Coastal Access – Harwich to Shotley Gate

Representations on:
Report HSG 2 - Ray Lane, Ramsey, to
Stone Point, Wrabness

Including Natural England's comments

December 2020

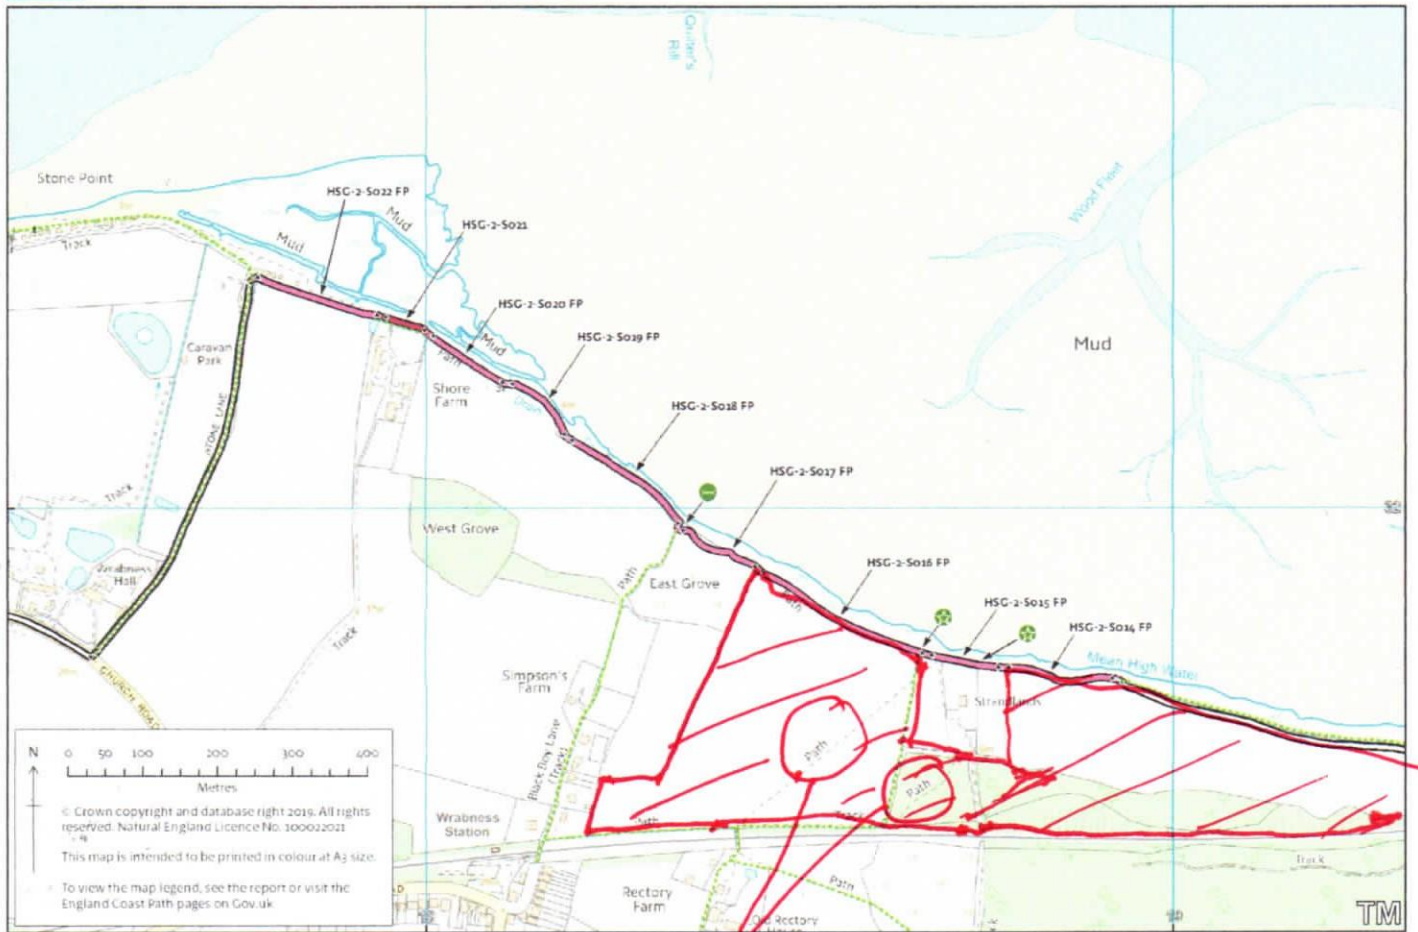
Other reports within stretch to which this representation also relates	N/A
<p>Summary of representation</p> <p>Map HSG 2c shows two dotted lines with the word ‘Path’ next to them, but the land is private, with no paths where they are shown. One was diverted after a Public Inquiry 15+ years ago. The inaccurate mapping will cause confusion among the public.</p> <p>[redacted] makes the case that 27 of his 29 fields are adjacent to, or contain, a public rights of way (PRoWs). Therefore “I understand (probably better than most) the confusion that is caused by inaccurate or lazy mapping”.</p> <p>[redacted] is concerned that the word ‘path’ is used for both PRoW and non-PRoW routes on the map, the only difference being that the PRoW route is also shown with green dashes. He makes the case that a colour-blind reader would not be helped by this distinction.</p> <p>“Natural England and its employees will not be there at a weekend helping me redirect the public off my land and onto the public rights of way. My efforts will be made all the more difficult as they wave this incompetent piece of mapping at me.”</p>

<p>Natural England’s comment</p> <p>Natural England have advised [redacted] that:</p> <ul style="list-style-type: none"> • Our role is to propose a route for the trail and certain features along its route (as well as any restrictions, exclusions, etc). It does not extend to mapping the landscape in general; we therefore use existing base mapping from Ordnance Survey (OS), overlain with updated PRoW mapping layers from access authorities, where these are available. We rarely become aware of errors in third party datasets/ mapping where they have no direct relevance to our proposals, and resolving such issues are outside our remit. • The terms ‘path’, ‘track’, etc, on OS maps refer to physical features that may be seen on the ground, and don’t imply a PRoW unless appropriately marked (in this case with a broken green line). Where these features are no longer evident on the ground, the third party mapping should be updated to reflect this; this is something [redacted] can take up with OS if he feels it appropriate. • The proposals we published on the internet, and deposited at public libraries and county council offices, relate specifically to the England Coast Path, that is the trail itself and the coastal margin. Our proposal documents are not intended as a guide to PRoW (which are separate legal entities), are not promoted as such, and we can’t therefore be held responsible for anyone using them in that way.
